Published date	06/21/2016
Document number	SUPAIR_2016/06_002
Page number	1 / 4

## SAFETY WARNING

**SUBJECT :** Chest strap's Safe-T buckle inadvertently opening in flight

*How to identify if my harness is concerned ?*

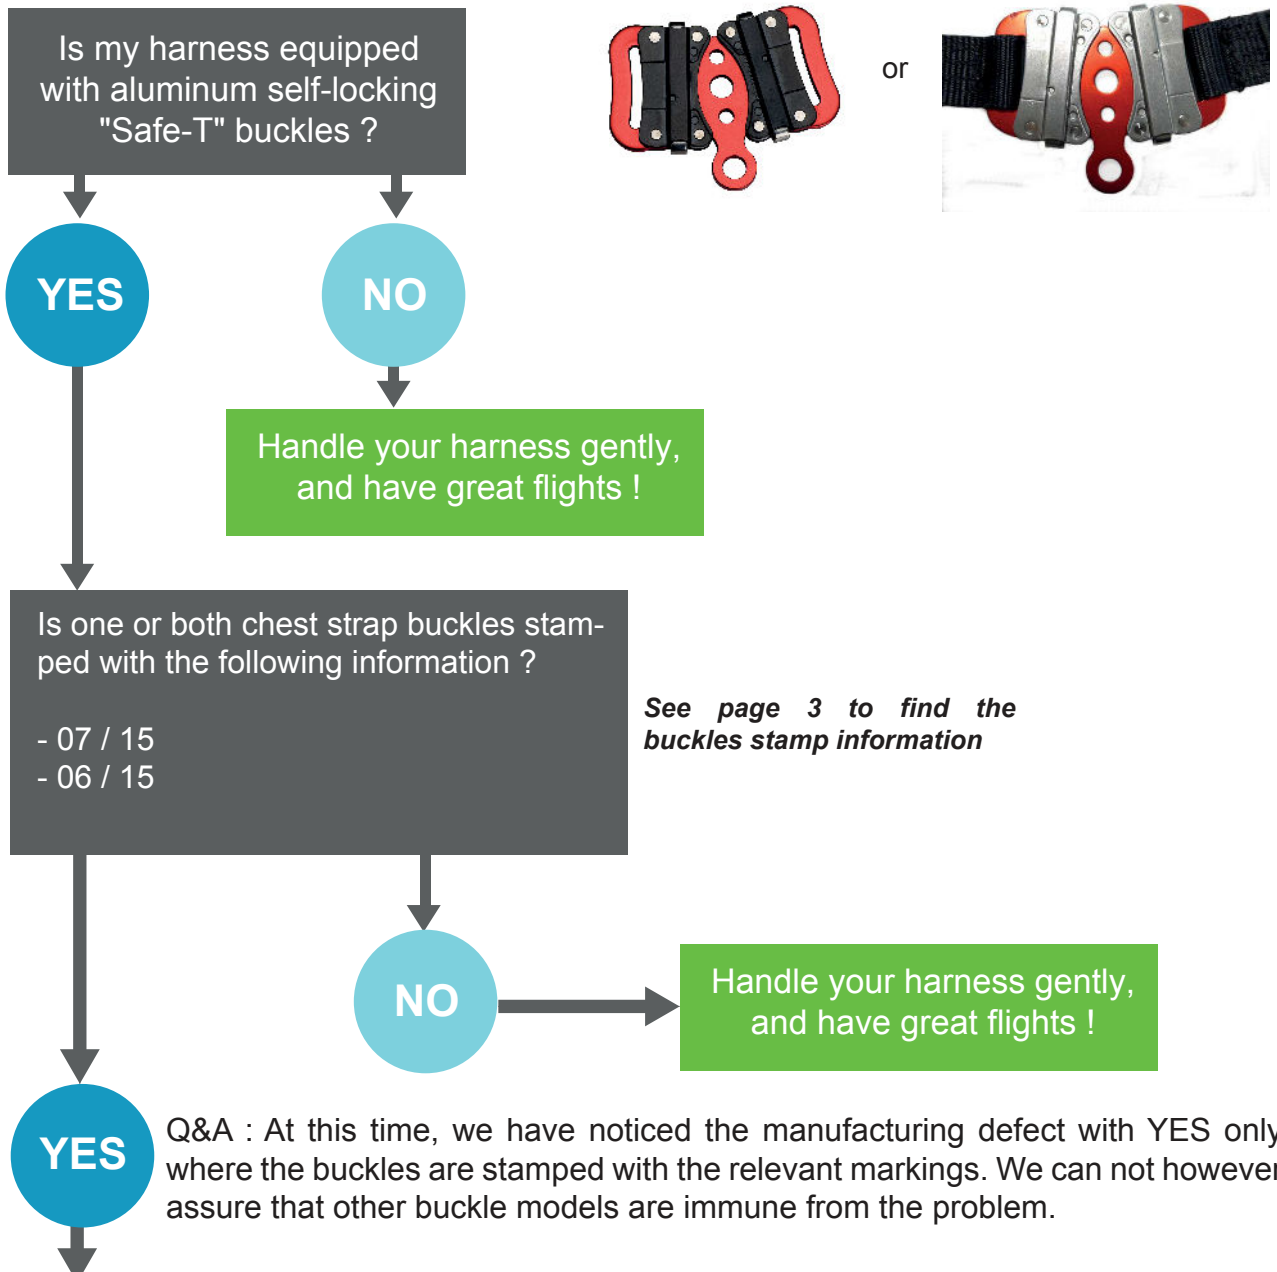
A few aluminum self-locking chest strap buckles used on selected SUP'AIR harness models may have experienced inadvertent opening in flight. The buckles sudden releases only concerns the "Safe-T" strap and rarely happens. The problem comes from a manufacturing defect invisible by the naked eye and non reproductive during a test.

If your harness corresponds to the above references :

- 1) Stop flying with this harness
- 2) Contact your nearest dealer/distributor or SUP'AIR directly
- 3) Depending on your harness model, an upgrade procedure will be made available to you.
